City Council Regular Meeting

Tuesday, February 18, 2025, at 6:00 PM

- <u>6.</u> Discuss and consider Appeal of the Takings Assessment related to the Hardy Tract project. Appellant: Jamie Rose, Greenberg Traurig
 - a. Staff Report
 - b. Appellant Presentation
 - c. Public Hearing -- Support and Oppose
 - d. Rebuttal -- Appellant
 - e. Appeal
- 7. Discuss and Consider approval of a Resolution Accepting the Petition Requesting the Consent of the City of Dripping Springs for Driftwood Conservation District to Annex Certain Property in the District. Applicant: Andrew Barrett
- 8. Discuss and Consider approval of a Resolution of the City of Dripping Springs Consenting to Legislation related to the Driftwood Conservation District. Applicant: Andrew Barrett

CONDITIONAL APPROVAL

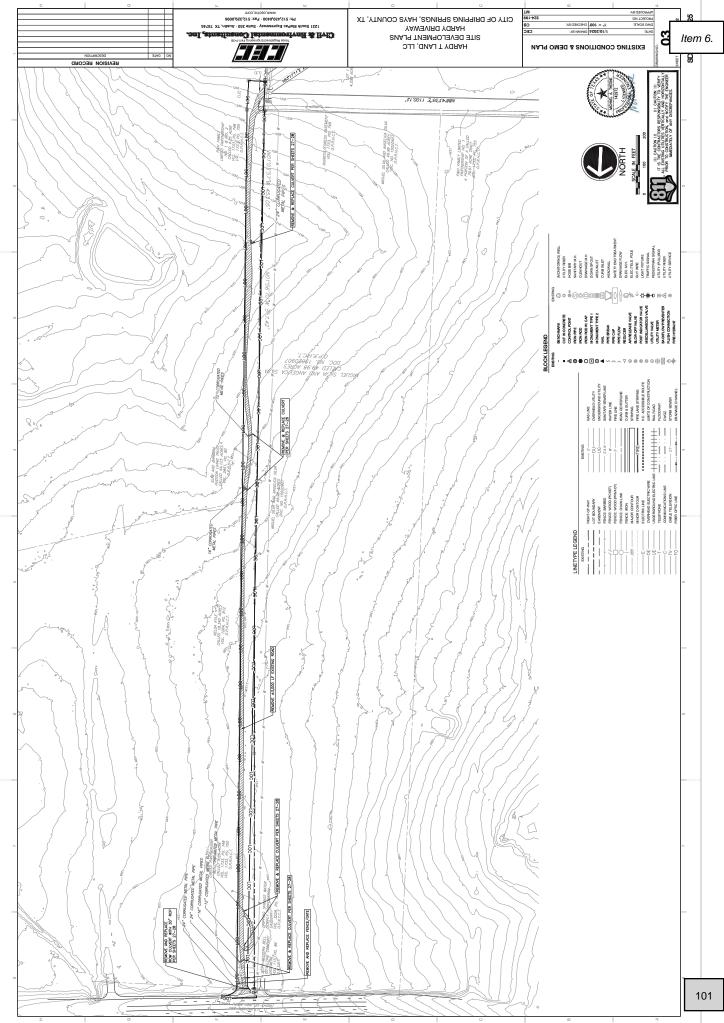
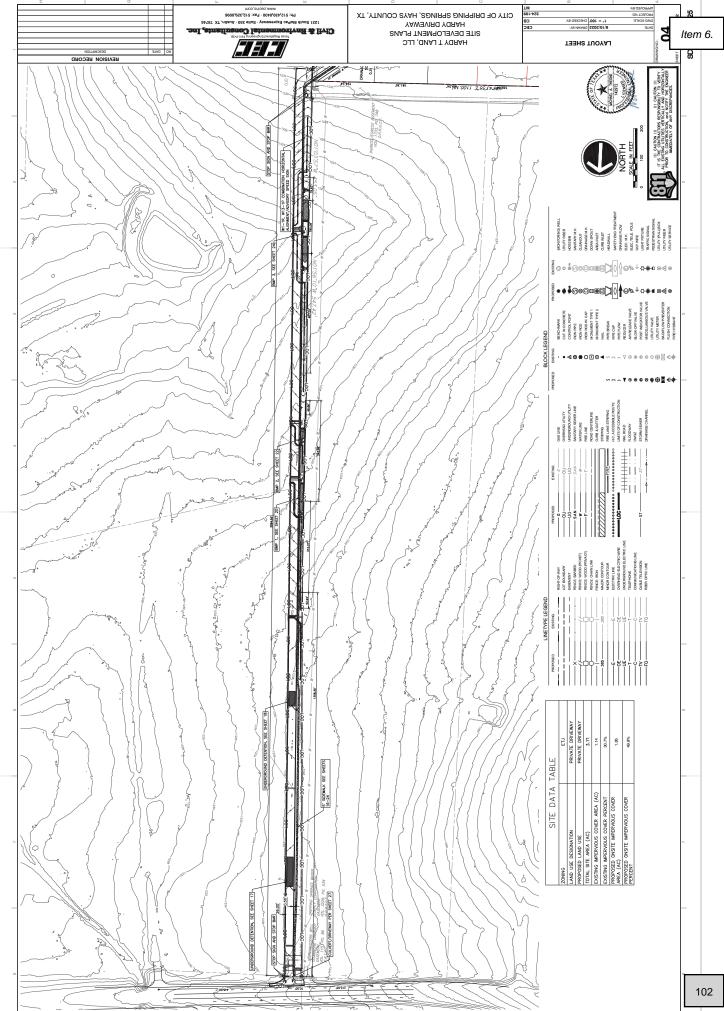
This letter is to inform you that the case SD2022-0025 HARDY DRIVEWAY has received a conditional approval. Each the following conditions must be addressed before the permit is approved.

- 1. Submit executed drainage easement document.
- 2. I do not see the level spreader details for the culvert discharge. Please add details or clarify location. The one detail reference 508S-13 is a standard headwall detail that will not fit the situation.
- 3. Confirm 100-yr flow is contained within the ROW. Provide an exhibit confirming the spread of the 100-yr is contained within the ROW.
- 4. Since this roadway is in the ETJ provide a signature block on the cover with approval by the County Transportation Department prior to submitting to the City for final approval and signatures.
